41, 45, and 47 West Main Street Façade Remodel Changes Project Narrative

Overview

CITY OF MESA: DOWNTOWN FACADE IMPROVEMENTS

Project #: CP0871 AND HUD #: IDIS 752

NEW CONSTRUCTION PLANS AND ELEVATIONS

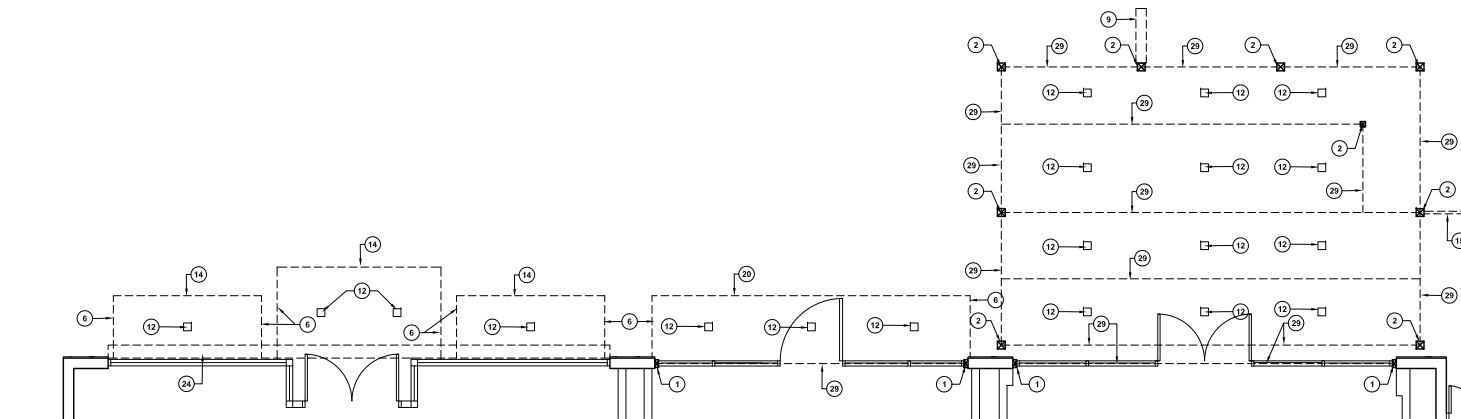
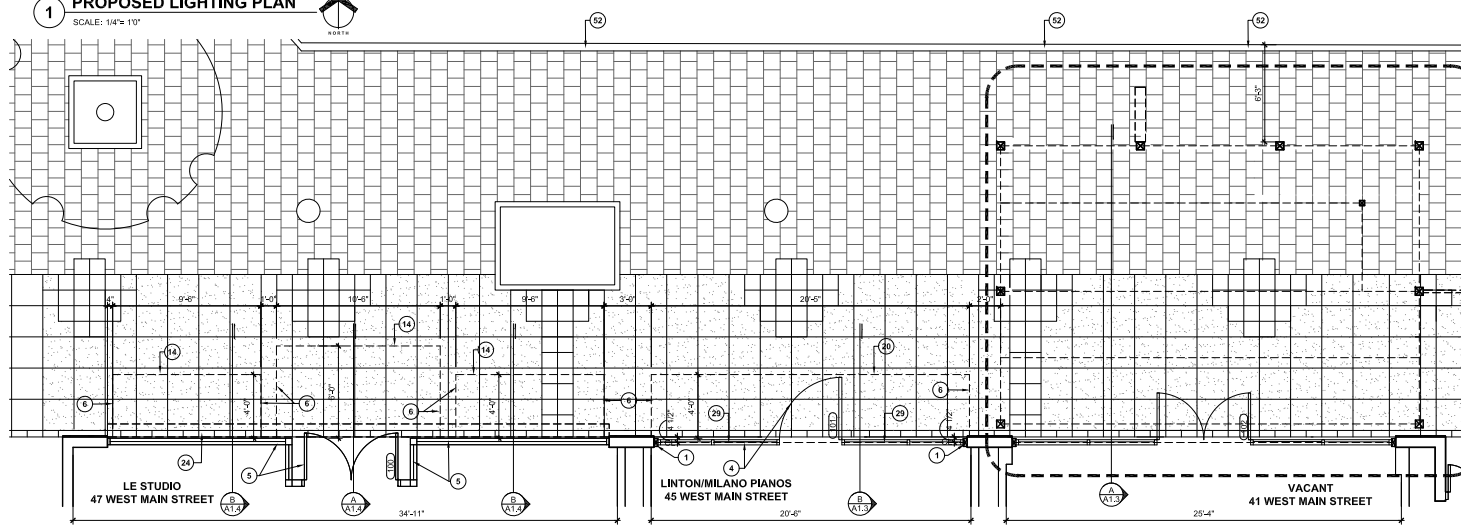
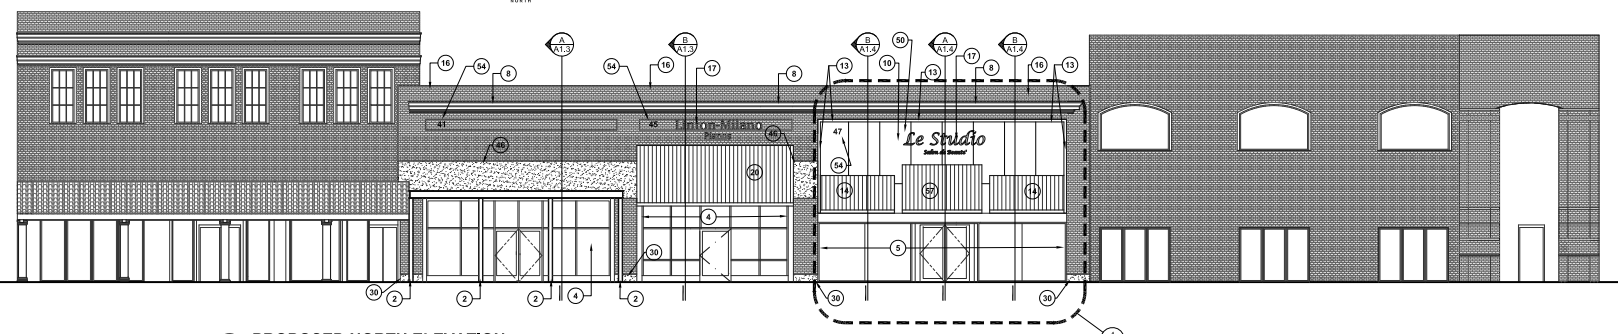
The existing colonnade will be removed and replaced with a new metal canopy, storefront door and taller window system. The new canopy will be self-supported, is made of 12" wide steel beams and metal deck supported by metal columns. The canopy and columns will be painted black to give it a more modern aesthetic and will provide significant shade over the pedestrian walkway. New exterior light fixtures will also be provided under the new canopy. The new canopy will have a clear height of 10'-5" which will provide increased visibility into the storefront and will provide an updated, refreshed, and attractive façade.

The existing colonnade will be removed and replaced with a new storefront door and window system. A 4' deep awning will be provided. The existing storefront is damaged to the point that the door does not close. The new storefront window and door system will be taller to allow more visibility into the store.

Remove existing steel columns adjacent to the building and remove the existing colonnade projecting into the right-of-way. The light fixtures mounted under the existing colonnade will also be removed and replaced. The existing 32'-2" storefront will remain. There will be 48" x 96" 9MM thick polished tiles added to the area above the three new canopies that will be installed over the front façade.
